76 Fitzjohn's Avenue, London NW3 5LS ref. 2017/1047/P

Delegated Report		Analysis sheet		Expiry Date:	11/05/2017
(Members Briefing)		N/A / attached		Consultation Expiry Date:	17/05/2017
Officer			Application Number(s)		
Laura Hazelton			2017/1047/P		
Application Address			Drawing Numbers		
76 Fitzjohn's Avenue London NW3 5LS			See draft decision notice		
PO 3/4	Area Team Signature	C&UD	Authorised Officer Signature		
Proposal(s)					
Creation of a single storey basement with lightwell to front and rear, installation of 1 x AC unit within front garden, installation of 3 x rooflights, removal of 1 x palm tree from front garden, alterations to side elevation fenestration, alterations to rear ground floor patio doors and erection of a new fence in the front garden.					
Recommendation(s):		Grant Conditional Planning Permission Subject to S106 Legal Agreement			
Application Type:		Householder Application

BH1

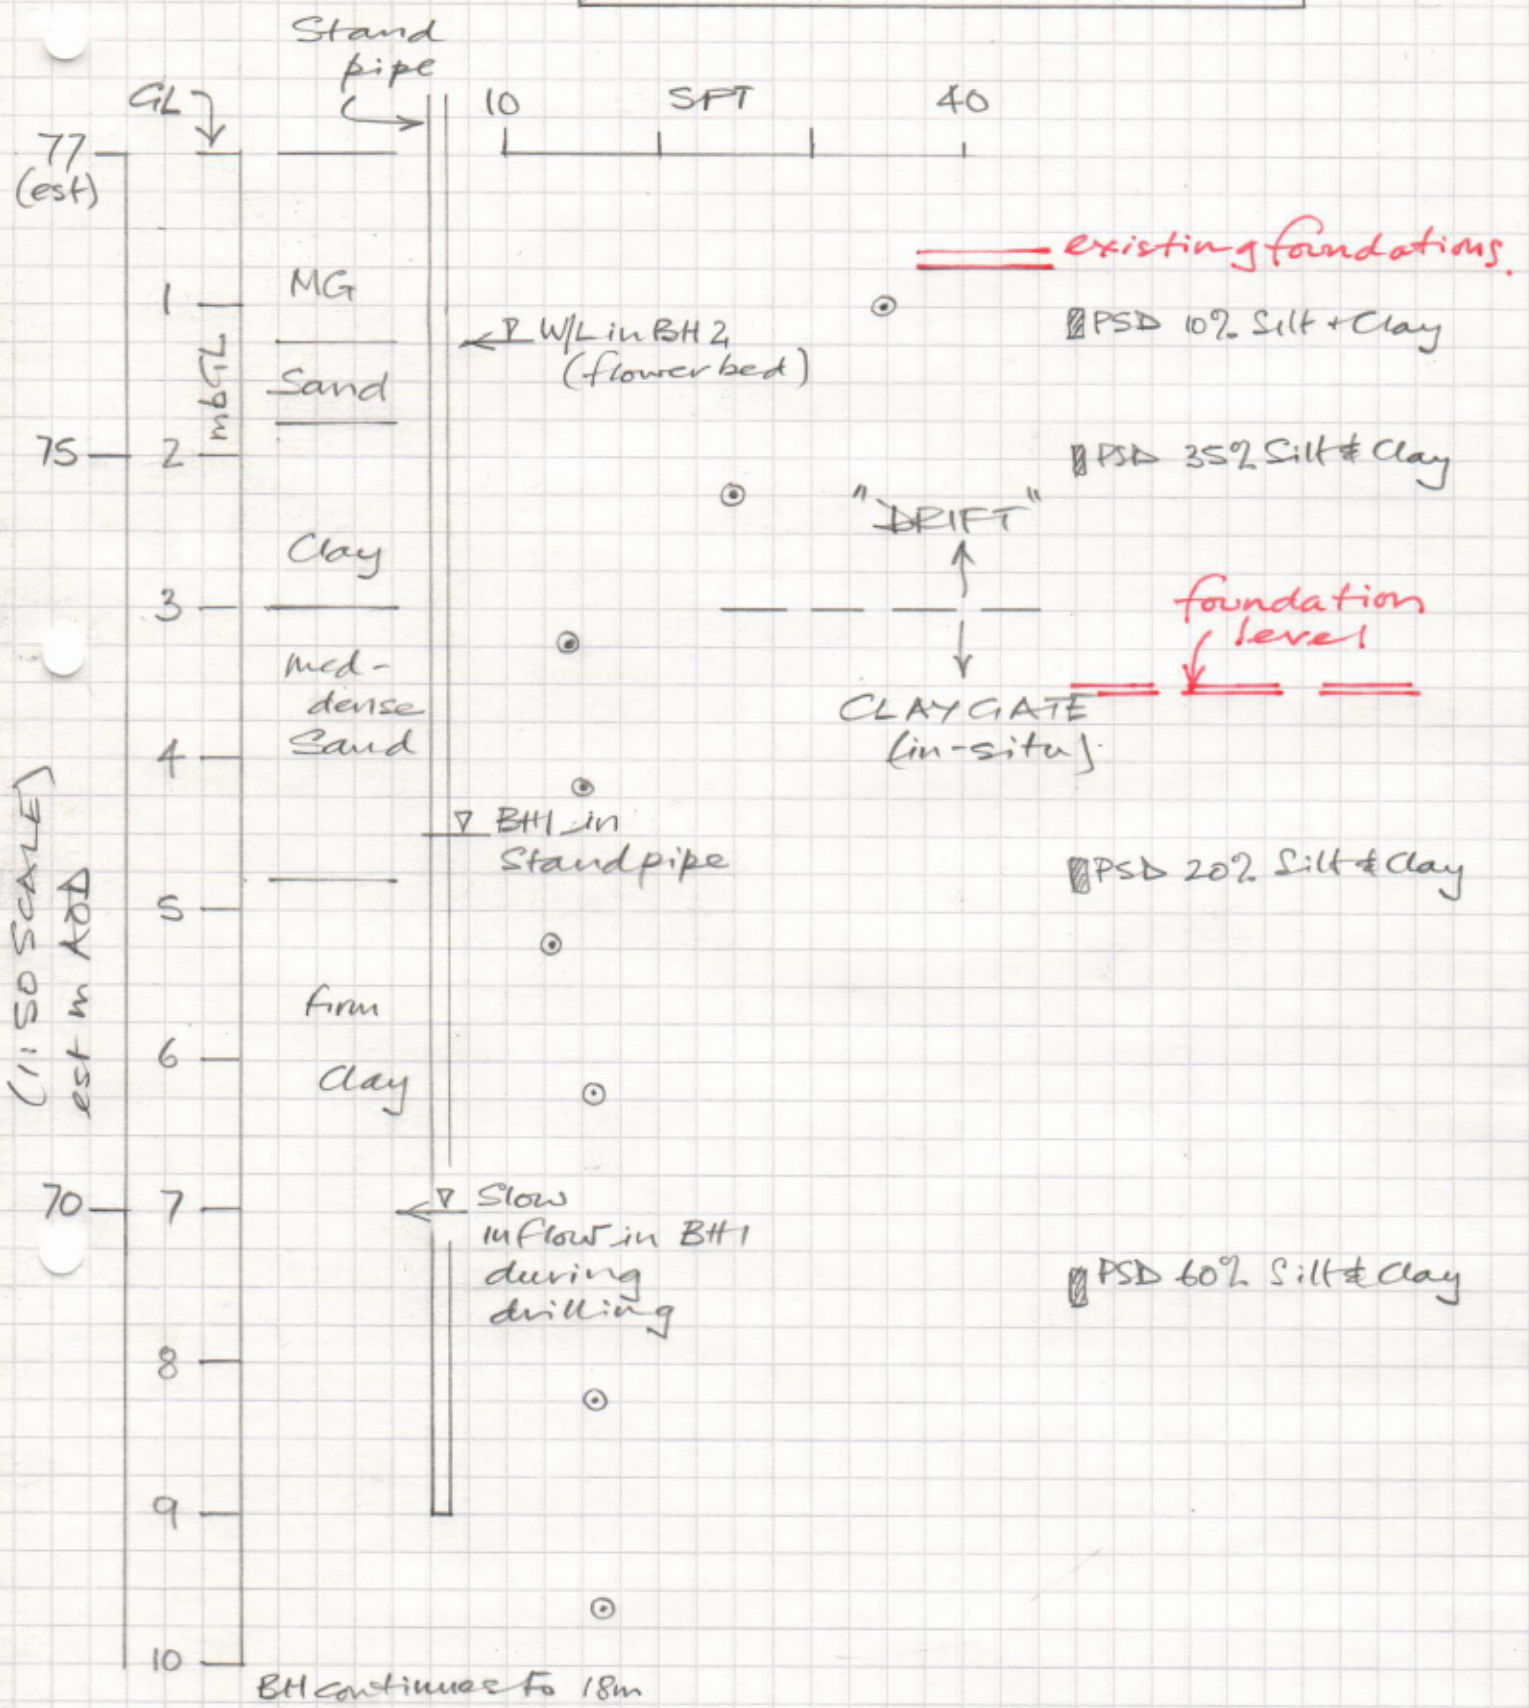
11. Thus the top 3m of this profile could all be transported material, carried down slope as mudflows and slides during the wet periods of the glacial past. Fig 1 illustrates that the measurements of in-situ strength (SPT) reflect a clear change in conditions at around 3m which supports that interpretation.

32. Fig.1 shows the position of the existing foundations for No.78 and the proposed depth of excavation for No.76. If anything goes wrong during excavation the stability of the party wall will be jeopardised. Recalling that little is known about the water levels in this ground and nothing is known about their response to rainfall, highlights the two hazards that could catch a contractor unprepared, and they are as follows.
